# 05

## Comments and Responses – Railway Corridor

G:\4123742\GIS\Maps\MXD\100\_Planning\41-23742\_114\_rev\_b.mxd

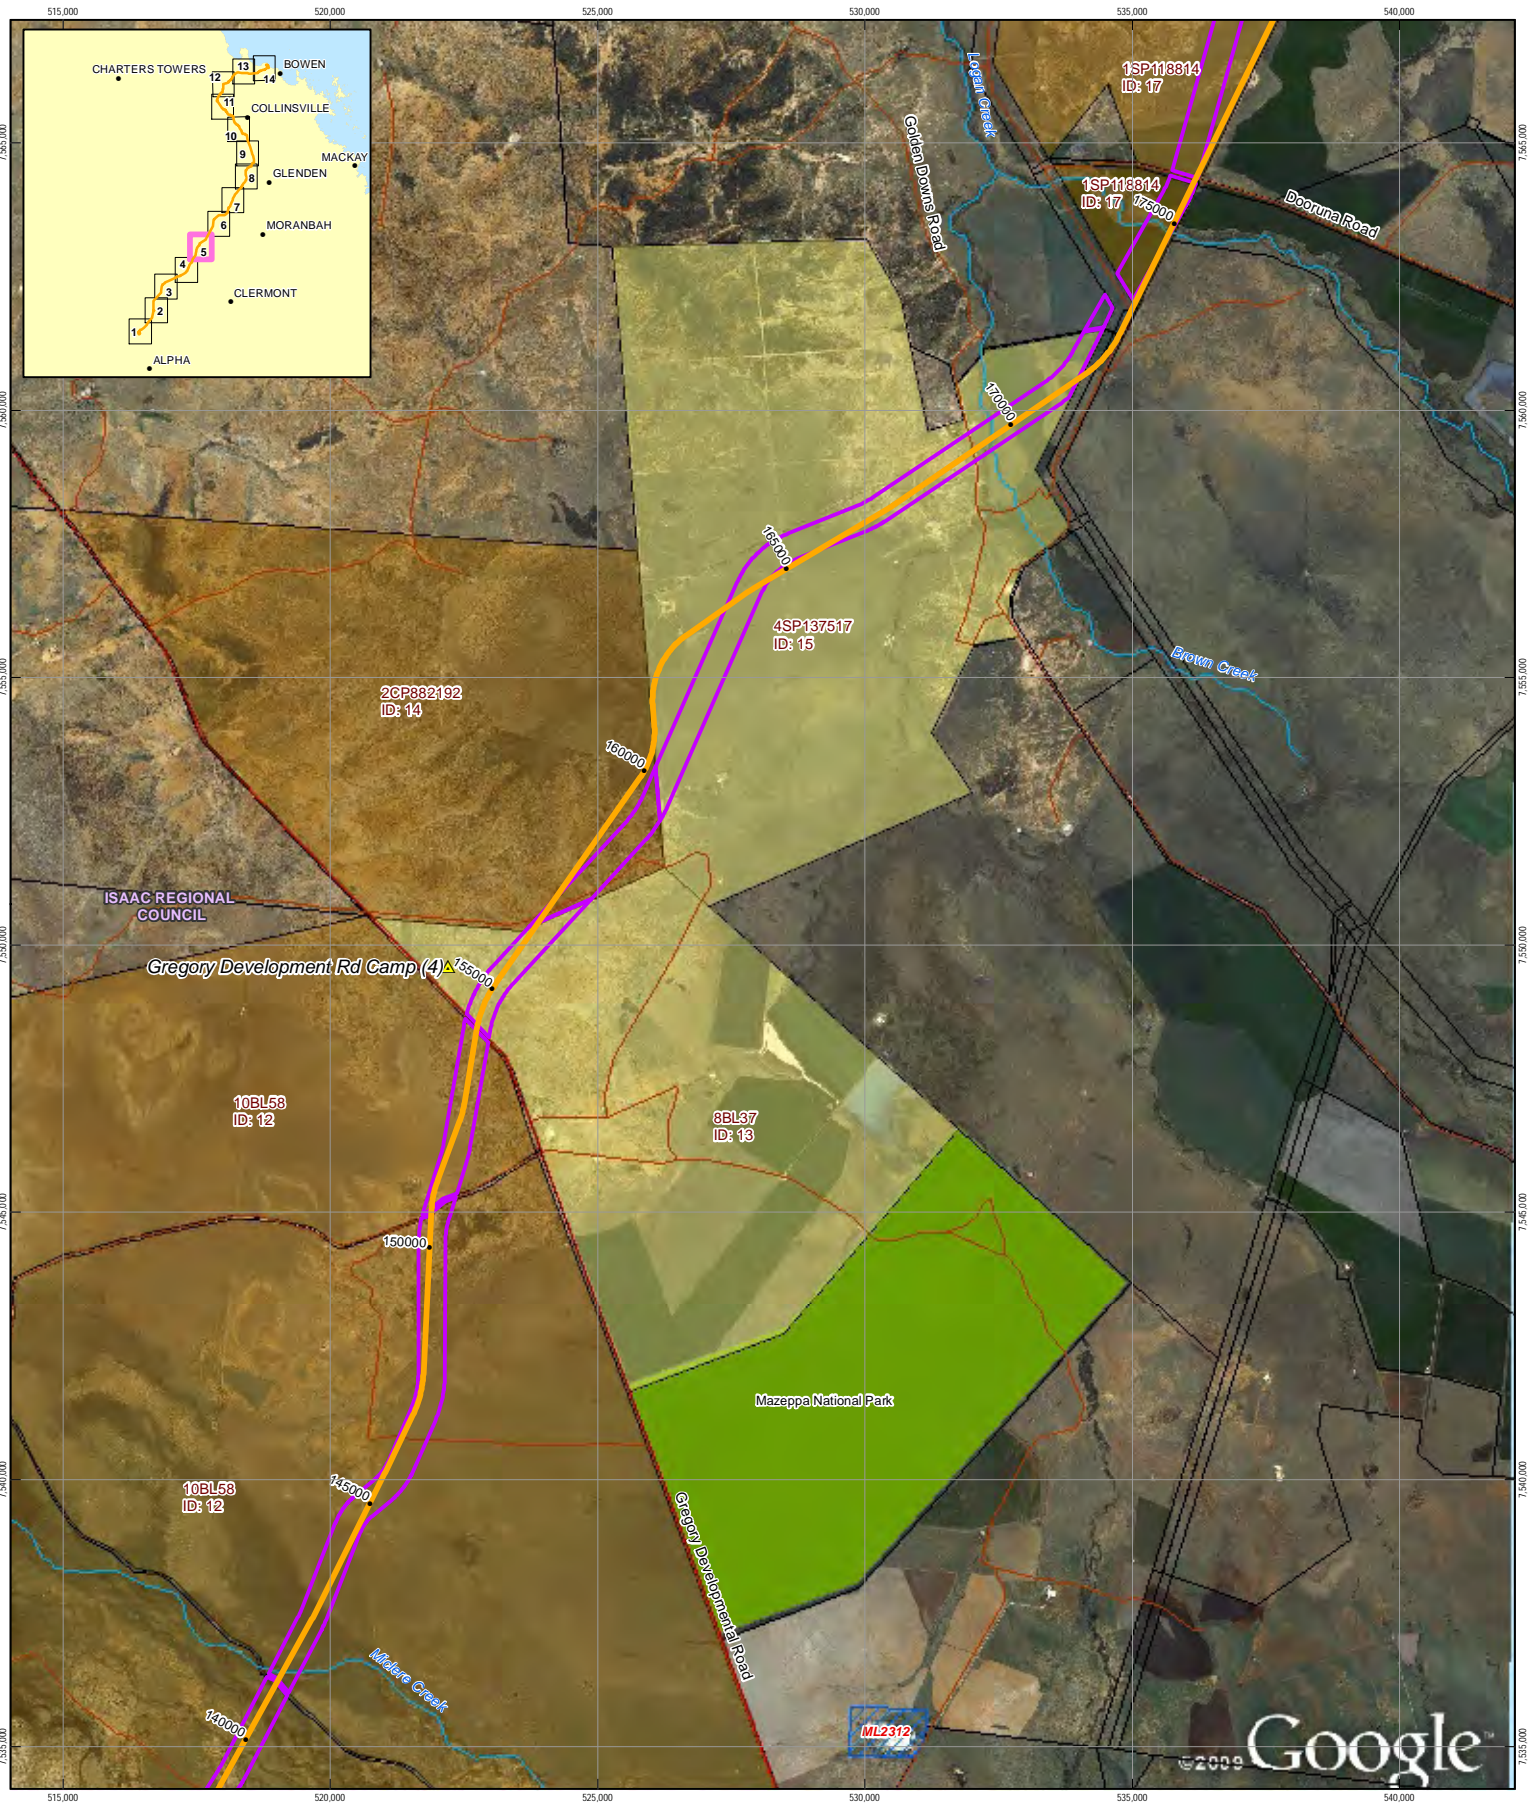
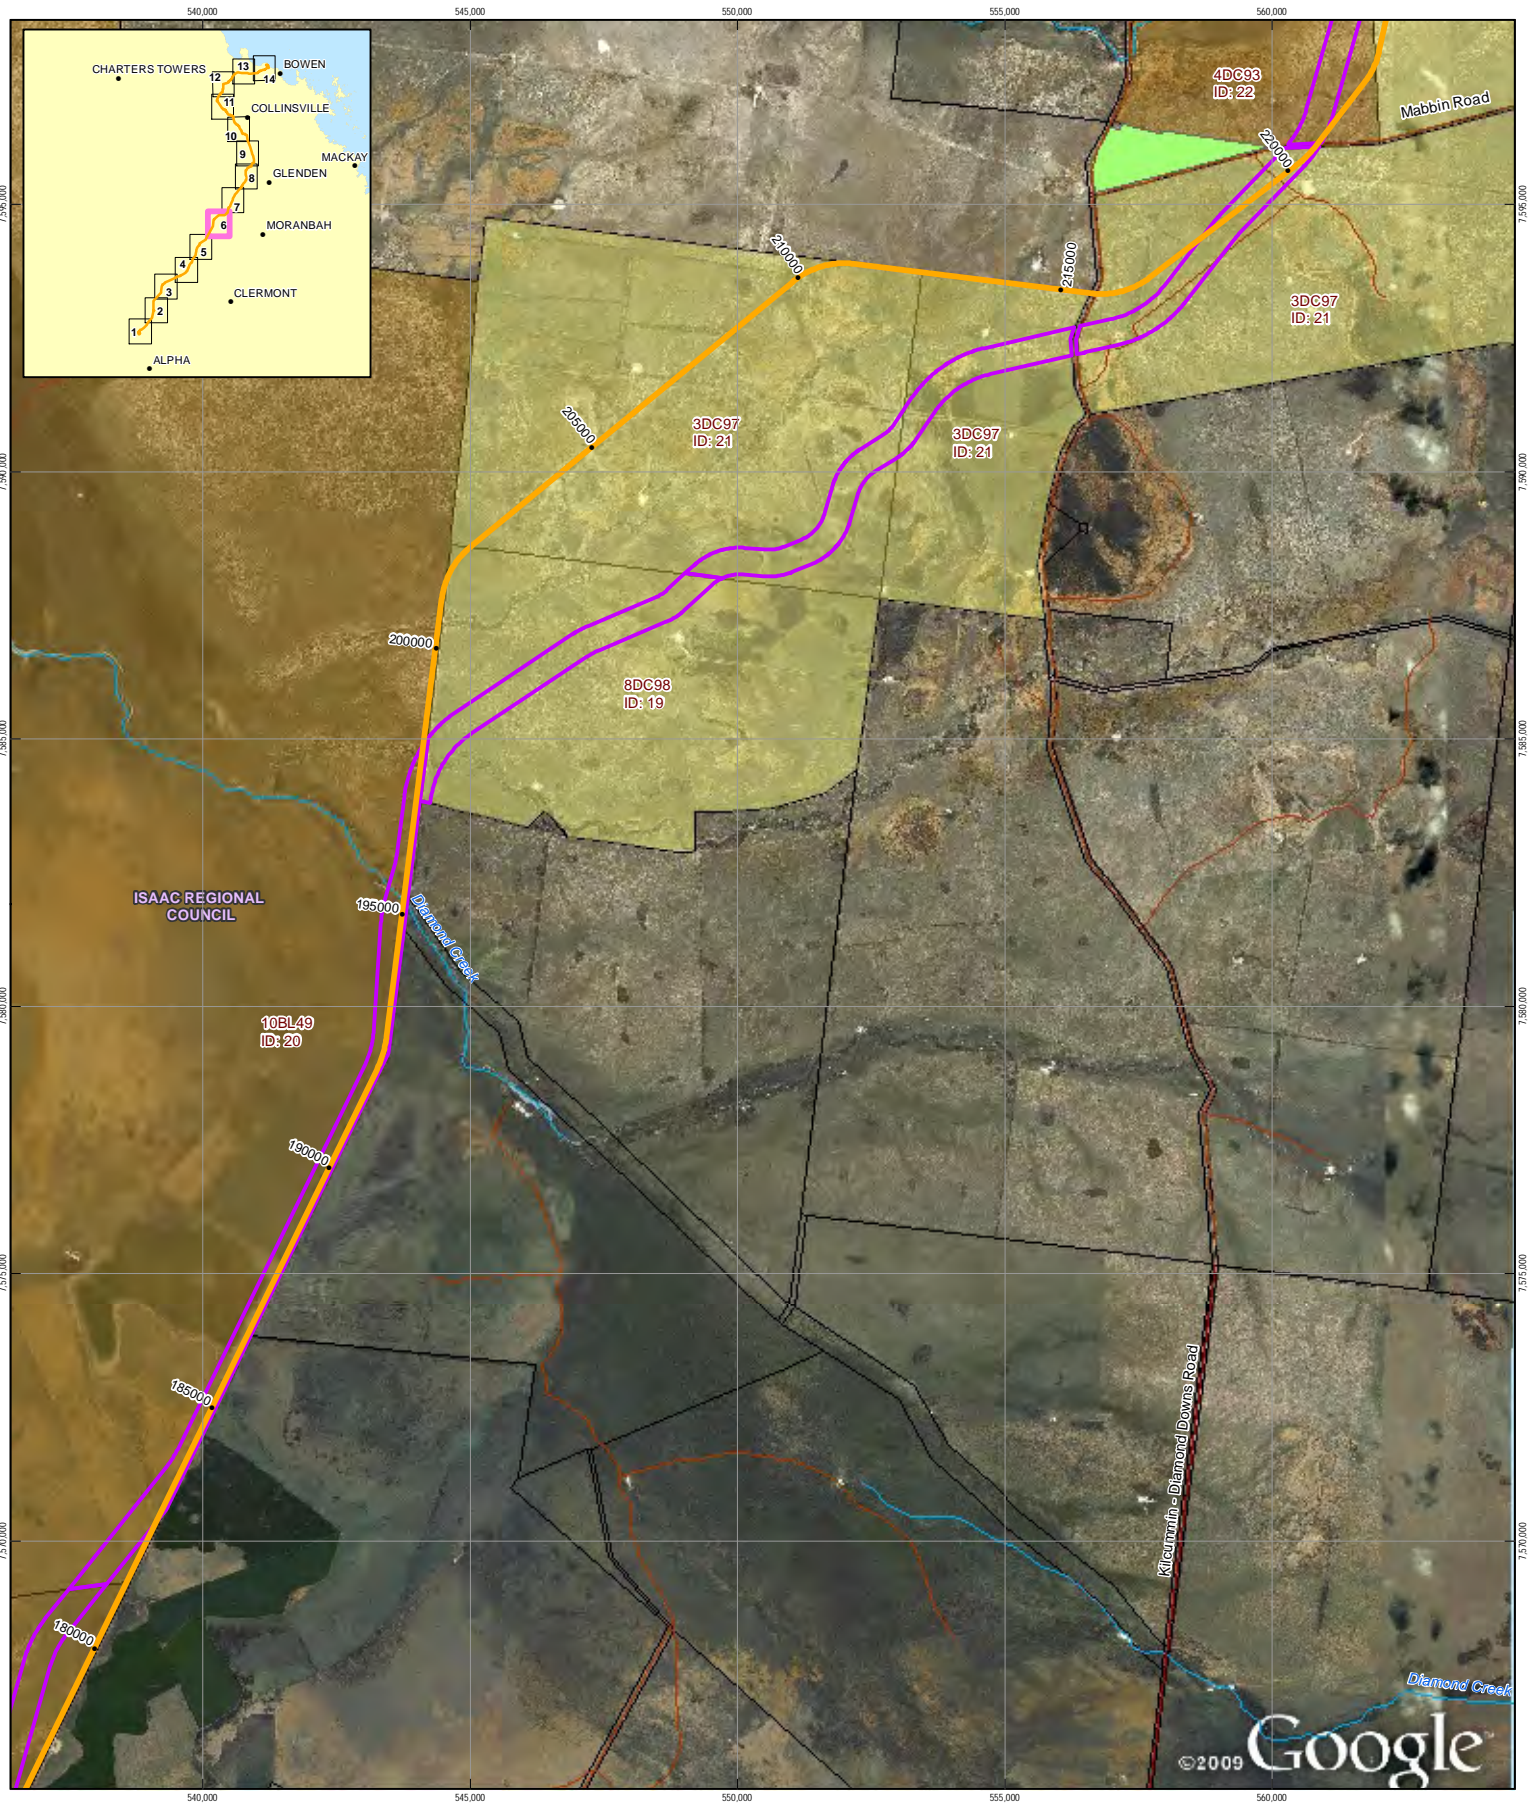
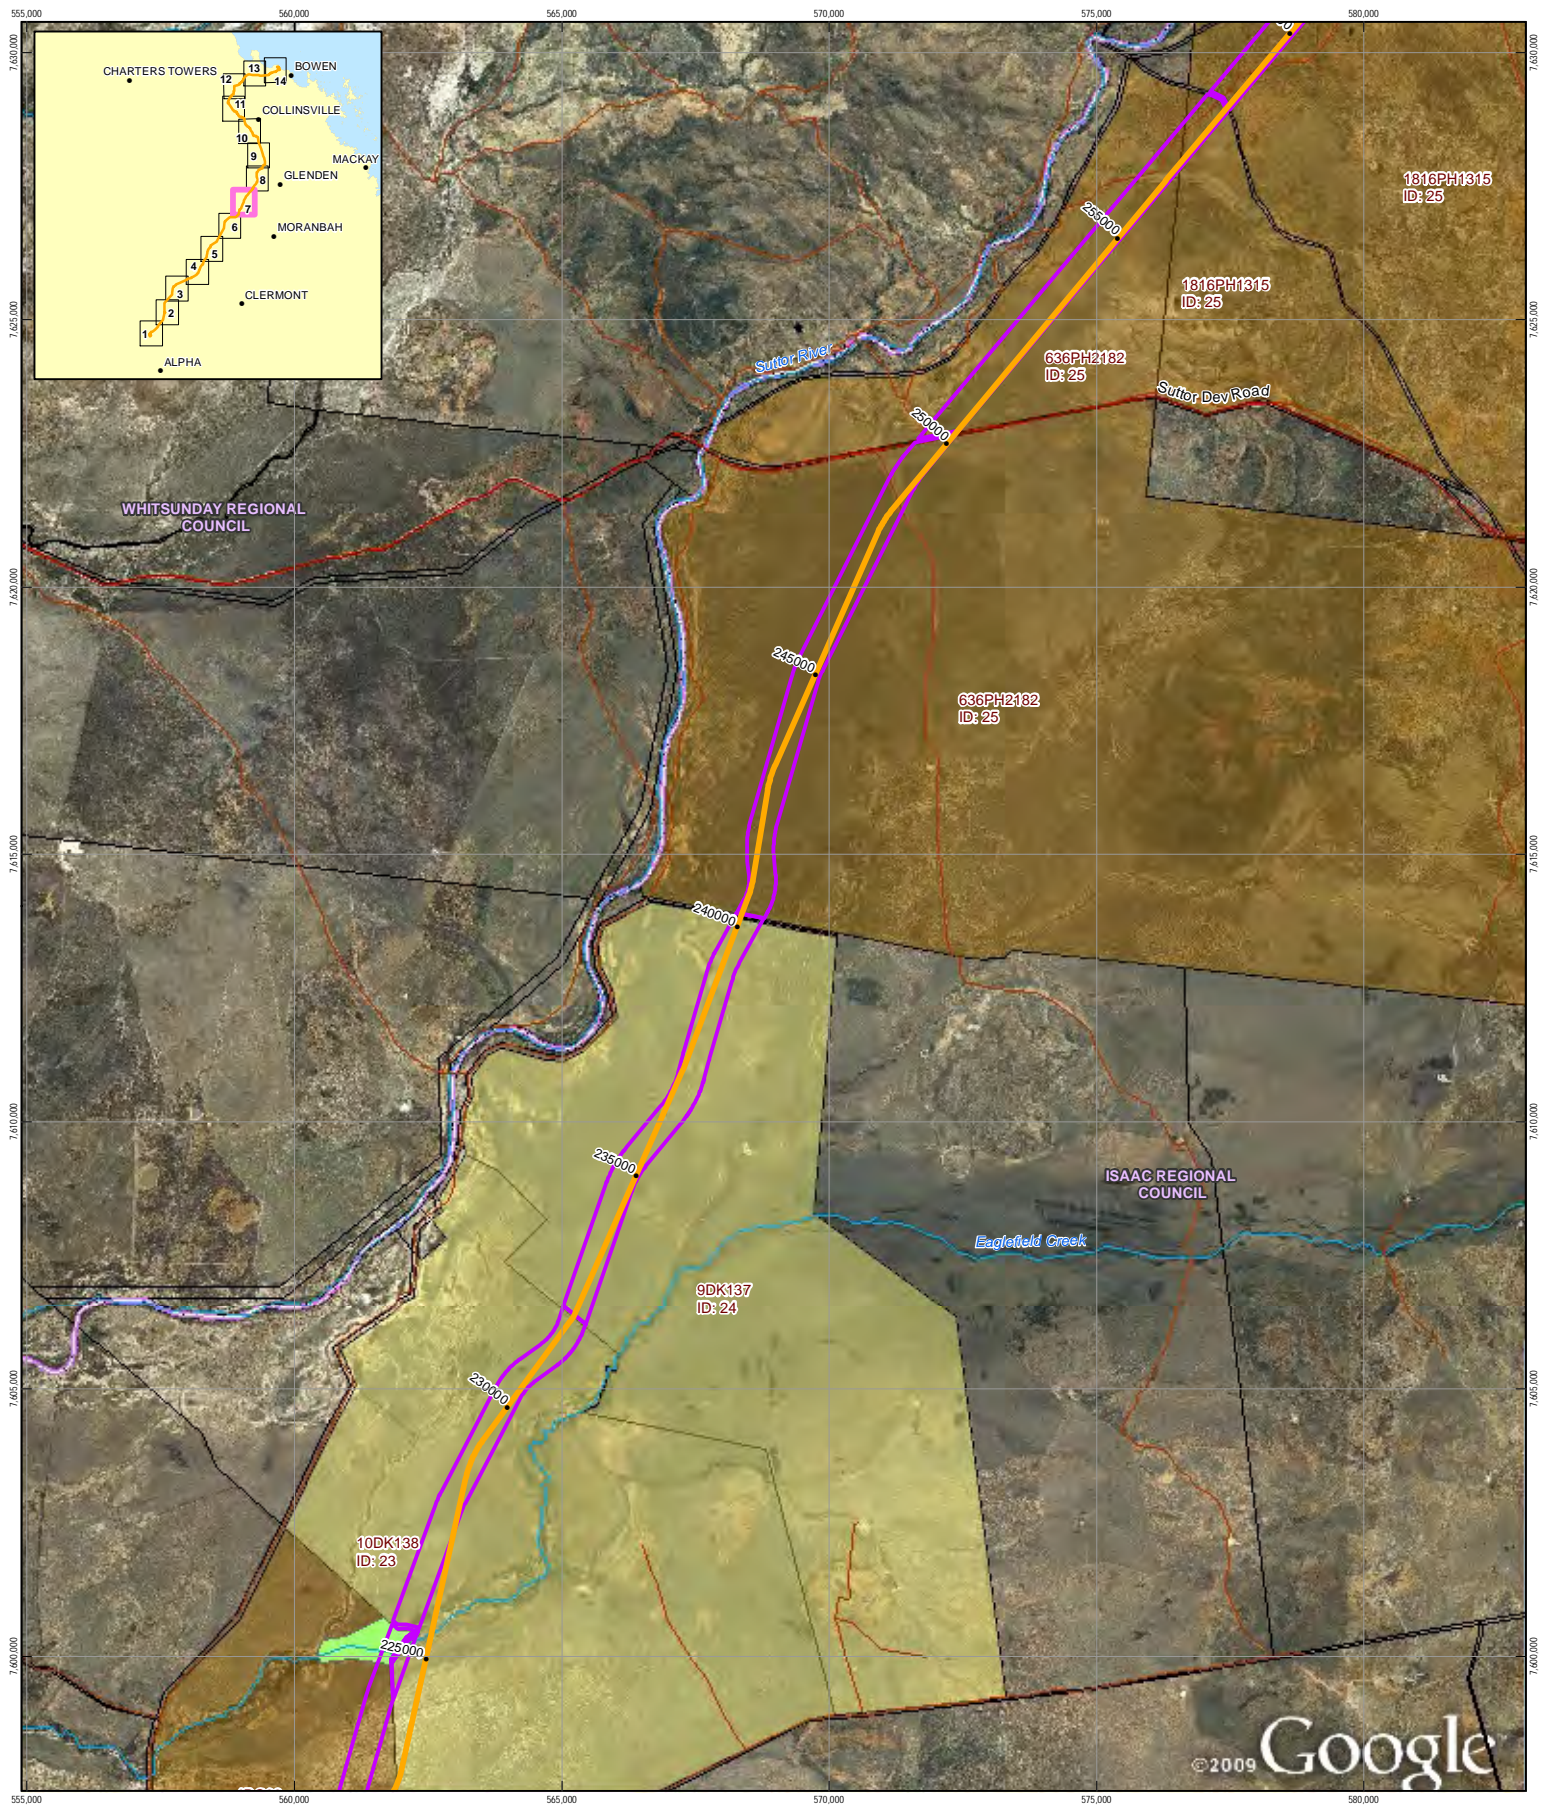
**Comment – RC405**

*The proponent has not delineated applications for MDL443 and MLs 10355, 10356, 10357, 70434, 70435 and 70436 on Sheets 8 and 9 of Figure 6. 2.*

Refer to amended Figure 5-3 below.
